CUSTOMER: Mason Flemming

LOW PROFILE SINGLE LID SADDLE BOX

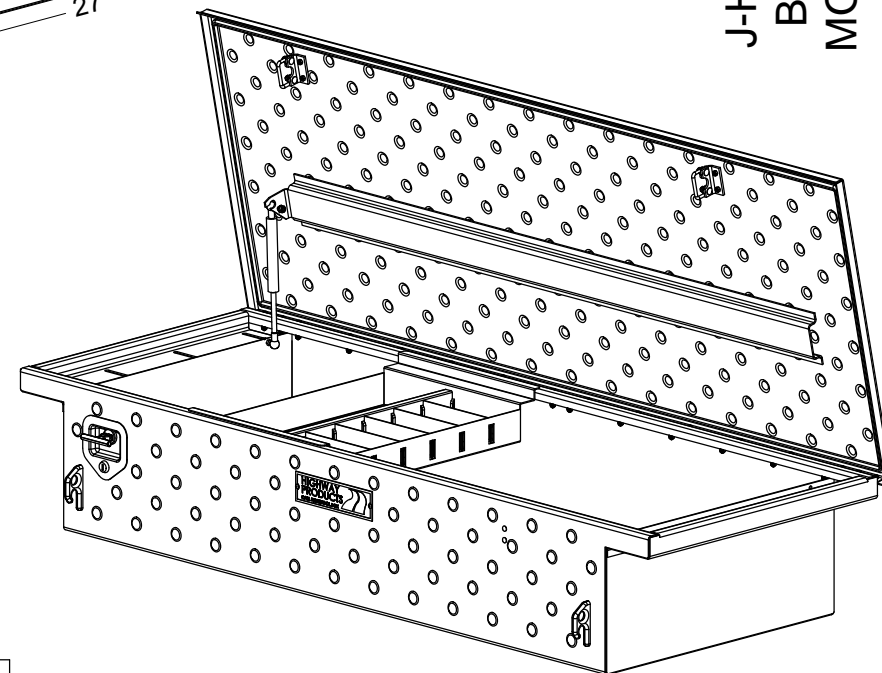
CUSTOMER NOTE:
J-HOOK MOUNT WILL NOT WORK.
BOX WILL REQUIRE DRILLING &
MOUNTING THROUGH BED RAILS.
